**RE: Proposed Tirawley Windfarm Project, Strategic Infrastructure Development
Application to An Coimisiún Pleanála under Section 37(E) of the Planning and
Development Act 2000 (as amended)**

Case Reference ACP PAX16.324258

ACP- PAX16.324258: Proposed Development of the construction of Tirawley Windfarm consisting of 16 no. wind turbines, including a 110kV sub-station on site, an energy storage system in the form of a battery array located within container units and all associated infrastructure

Fig. 1. Pre-bog walls Belderrig – Lacken, with known Neolithic field system marked in red, approximate location of Tirawley WF in yellow. This map is on display at the Visitor Centre.

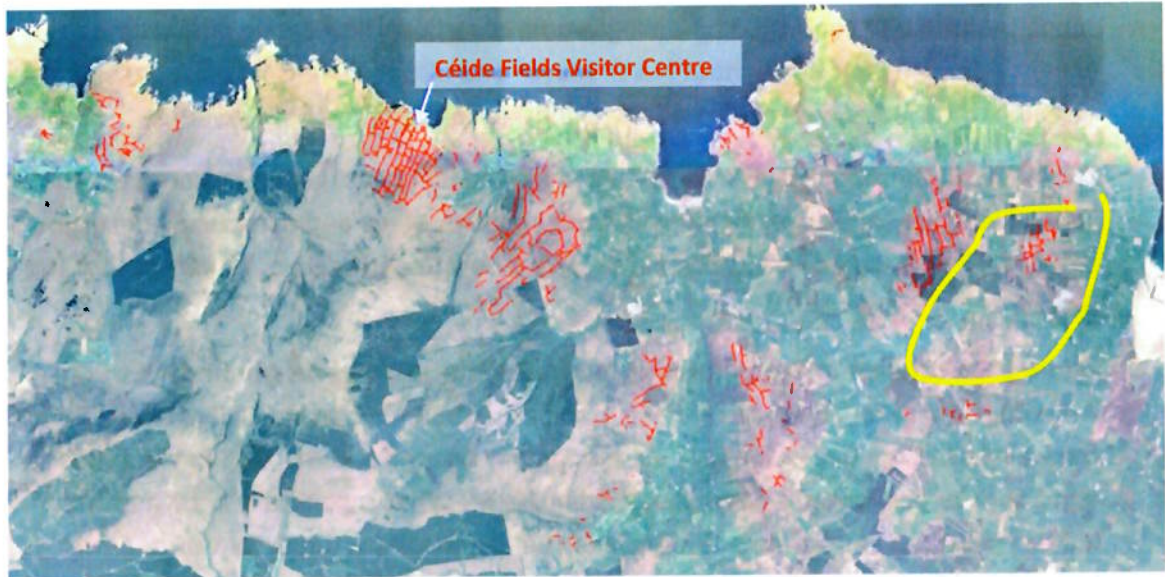
The Neolithic field boundaries clearly extend through the area of the proposed Tirawley wind farm. The red lines in the map in Figure 1 show walls that have been located and originally mapped in great detail at a scale of 1:2,500. There are certainly many more walls that have not been found and mapped. Those that have been located were found by intensive surveying of field walking and detailed probing in the 1980s and 1990s. Areas of bog on the maps that do not show red lines are not evidence of absence of walls, but are simply areas that have not been surveyed. It was impossible to find walls in areas of forestry, visible as dark green on the satellite images. Some areas of forestry in the east of the area towards Lacken do have some mapped walls, which were located and mapped in 1984 and 1985, prior to the planting of the forestry a few years later.

Although extensive field boundaries have been mapped, there are certainly many more walls that have not yet been mapped. Areas of bog on the maps that do not show red lines are not evidence of absence of walls, but are simply areas that have not been surveyed. There is a very high probability that there are undiscovered archaeological remains within the boundaries of the proposed wind farm.

Fig. 2 Recommended locations marked X in purple for additional visual impact assessments. The OPW also request a Visual Impact Assessment from the rooftop viewing platform

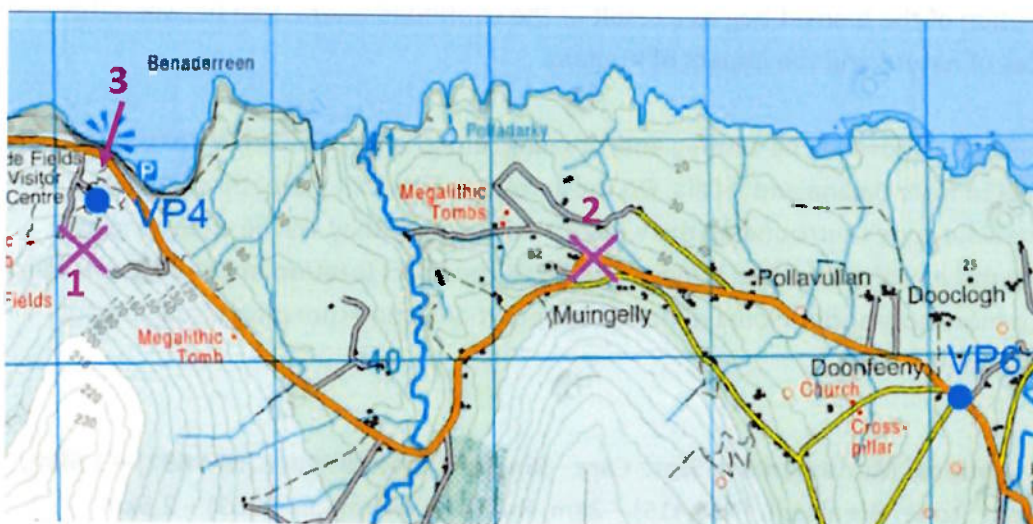
In Table 12.9 the Céide Fields was selected as view point VP4. The photographs used for the Landscape and Visual Impact Amenity Viewpoint Photomontage Booklet Book 1 images were taken from just outside the Visitor Centre building on the lowest level of the boardwalk guided tour route. In practice, the best location to view the surrounding landscape from the guided tour route is at the highest upslope part of the route (marked X1 on Figure 2 below) where the guides will point out the extent of the Neolithic field systems from Belderrig to Lacken. Lacken is directly beyond where the turbines would be in view. The visual impact from the turbines would also be greater from this location. Similarly, more visitors would admire and photograph the views from the rooftop viewing platform of the Visitor Centre) than from where the photographs were taken. This location is considerably higher than the level of the photograph with a greater visual impact from the turbines. Perhaps the most photographed view from Céide Fields is from the cliff edge viewing platform Discovery Point on the Wild Atlantic Way (marked 3 on map) looking eastwards across the sea. This takes in the dramatic Signature Discovery Point of Downpatrick Head and also the skyline with the proposed turbines. The view from the platform includes a wider section of the hill on the eastern horizon than the photograph in VP4 where it is more

obscured by the foreground Sralagagh Hill. At least one further turbine will be visible on the skyline.

Almost all visitors will be coming and/or going, either along the WAW coastal road or the R314 from Ballina and Killala. On these routes, they will travel through the immediate zones surrounding the wind turbines where they will be experiencing a much more profound visual impact. The OPW considers location marked X 2 on Figure 2 is a more appropriate location for a Viewpoint and corresponding Visual Impact Assessment.

The OPW requests that ACP request the applicants to provide three additional photomontages and visual impact assessment relating to the Céide Fields visitor experience (reference Fig. 2).

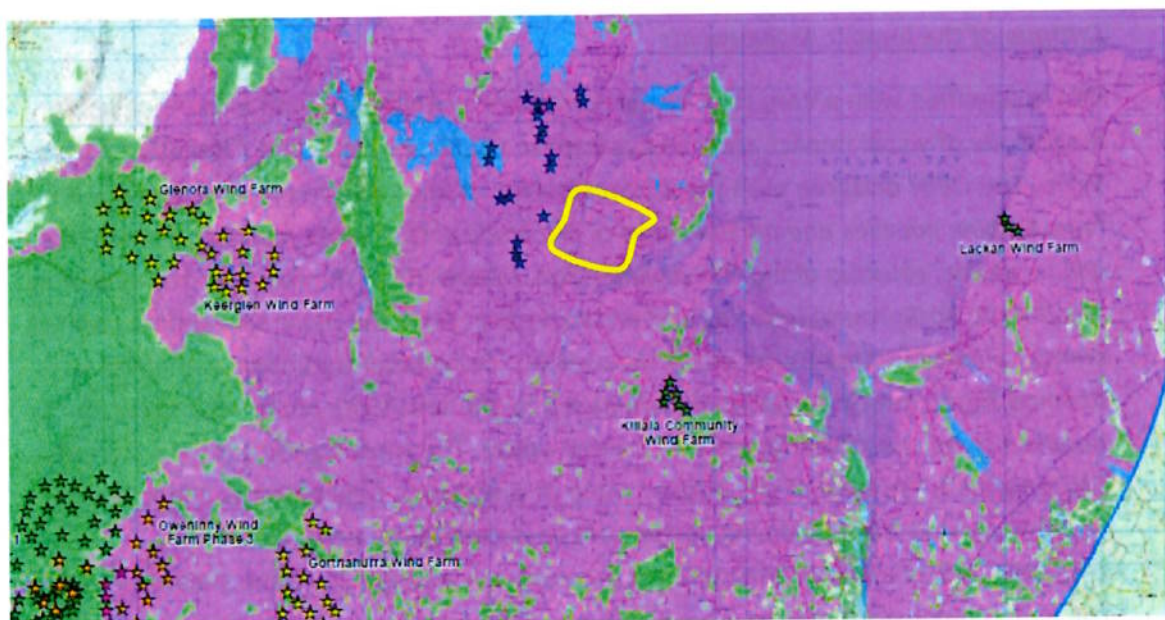
VP4 is classified with a Very High visual receptor sensitivity but with a Low-negligible magnitude of visual impact and a visual impact significance of Slight / Negative / Long Term. The OPW disagree with these assessments of impacts. On page 57, it is stated, *"two turbine nacelles and partial views of the blade sets of up to four further turbines will be visible, rotating along the skyline ridge. Nonetheless, the turbines are viewed as small-scale background features and are well offset from the more susceptible coastal context viewed further to the north. As a result, the residual significance of effect was deemed Slight, which is principally influenced by the sensitivity of the visual receptor as opposed to any notable magnitude of visual effect."* The most significant view from the Céide Fields is the view of the entire sweep of prehistoric field systems under blanket bog that extend from Belderrig in the west to Lacken in the east. This is what consistently overawes visitors and it is the only way to appreciate the sheer scale of the archaeological landscape. These turbines will be visible on the horizon exactly over the eastern limit to the visible area of bog-covered prehistoric landscape. They will also

detract from the appreciation of the subtle changes in the natural landscape from the complete blanket of peat to the west and south and the gradual decrease in coverage of peat towards the east. The fundamental story of Céide Fields is the prehistoric evolution of the blanket bog as a result of the continued interaction between the forces of nature and the impact of humans.
